Original Issue May 6, 2025
Revised June 9, 2025, with Contra Costa Health MRC Oversight Committee Comments
Revised September 12, 2025 with Public Hearing Comments (6/17/2025)

Final Report
Independent Incident Investigation/Root Cause Analysis
of the
Martinez Refining Company LLC
February 1, 2025 Loss of Process Containment and Fire

Contra Costa Health
Attn: Nicole Heath, Michael Dossey

Figure 1 is a drawing showing the piping arrangement, including the planned blind installation location at Flange #3. Flange #4 which was incorrectly opened, causing the initial leak.

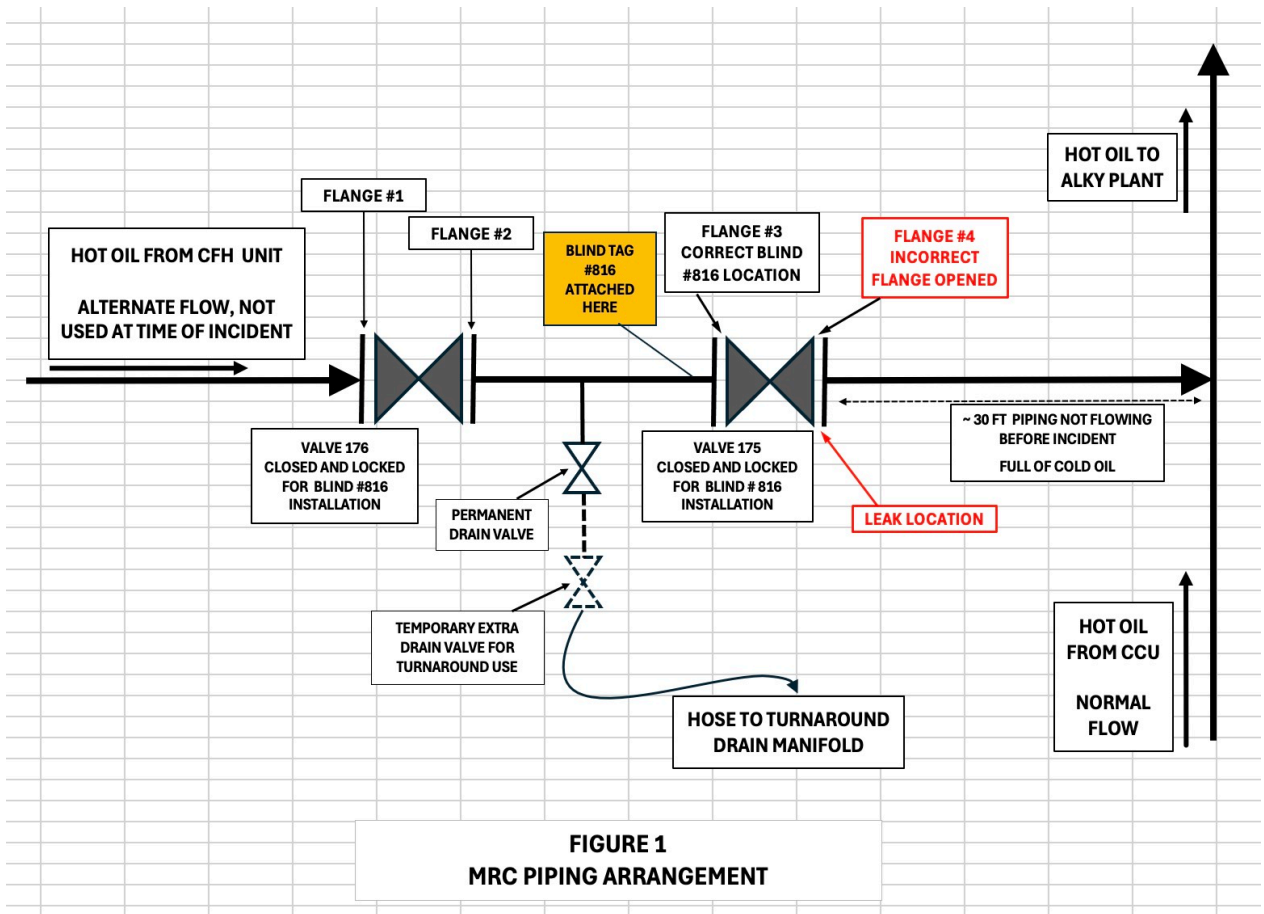
Heidi Taylor	Did the workers receive clear instructions or job-specific training for this task? Why did they switch from the correct flange (#3) to the incorrect one (#4)? Was there mislabeling, poor visibility, or distraction? What factors caused the miscommunication?		Based on interviews with multiple individuals, it appears that communications were clear, and that the instructions and labeling were proper. A verbal summary of the metallurgical examination and testing results from an independent lab were provided by MRC to JEM Advisors in late May 2025. The updated information indicated that Flange #3 stud bolts were loosened by heat effects of the fire originating at Flange #4, and JEM has changed the report text to reflect this. It is not clear why the contract workers opened the wrong flange.	Report has been amended with footnotes 1 and 2 to reflect more current information that heat effects of the fire likely caused the loosened bolts on Flange #3, rather than the workers loosening this flange. The workers did loosen 4 bolts on the "live" Flange #4.

Heidi Taylor	Were the loose bolts on 3 or 4? I thought they were on 4.		<p>Response provided in recording of 6/3/25 meeting.</p> <p>Flange #4 had 4 bolts loose on the bottom side of the flange, loosened by the steamfitters.</p> <p>Flange #3 had all bolts loosened, apparently from heat effects of the fire. The laboratory contracted by MRC to investigate this found bolt elongation, thread deformation, and reduced hardness in the steel, all evidence of very high temperatures on Flange #3.</p>	No change to document.
Heidi Taylor	*Comments have been rephrased to assist in readability. So I read that GSCS, (whatever GSCS is) was on the job, and then Timec at comes around and says, Oh, hey! We don't have anything to do. We're going to just pop in on here. So to me, that indicates an issue and I'm wondering why there was that change of contractor? Shouldn't it be consistent that one contractor be in charge of this and follow it from start to finish? Are these two contractors equally qualified, and did they attend whatever these briefings were that didn't filter down?		<p>Response provided in recording of 6/3/25 meeting. Global Scaffolding Construction Services were initially assigned to install Blind #816. On Feb 1, 2025, TIMEC had people on site without work, so this job was reassigned to TIMEC. Reassigning work to optimize productivity is not uncommon. Either company should have been capable of safely executing this work task. JEM did not interview GSCS or evaluate their capability. TIMEC did have 2 managers attend the Turnaround Onboarding presentations and all contractors were emailed a copy of the onboarding presentation.</p>	No change to document.

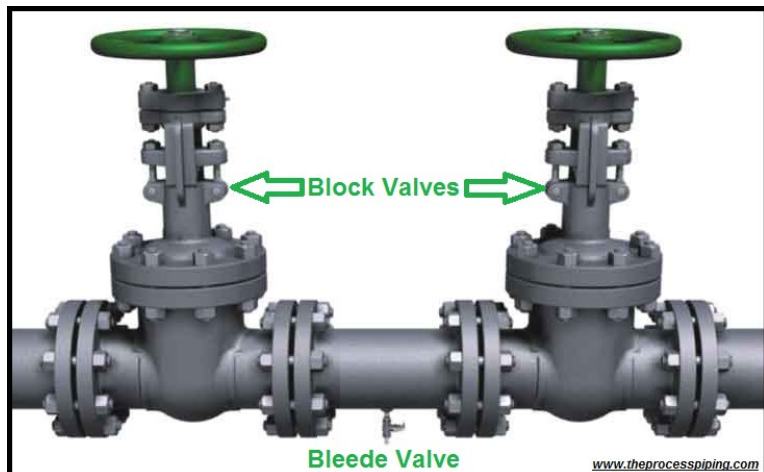
CCH	Suggest adding a picture of a flange to help readers full visualize what it looks like. Can be added in the glossary or the report. (Page 3)		Agree	Pictures of flange, blind, double block & bleed, valve, and stud bolt added to Appendix 1 - Glossary of Terms
CCH	Page 6, add double block and bleed spool to glossary		Agree	Added to Appendix 1 - Glossary of Terms with picture
CCH	Page 6, blind tag: suggest this be expanded to say something like this is to be placed on or near the flange to be fitted with a blind and is used as a visual indicator of which flange is to be opened		Agree	The suggested wording was added on Page 6.
CCH	Page 8, is just one flange or a set?		Flanges are often referred to as a 'set of flanges'. Two flanges are bolted together with a sealing gasket to	No change to document.
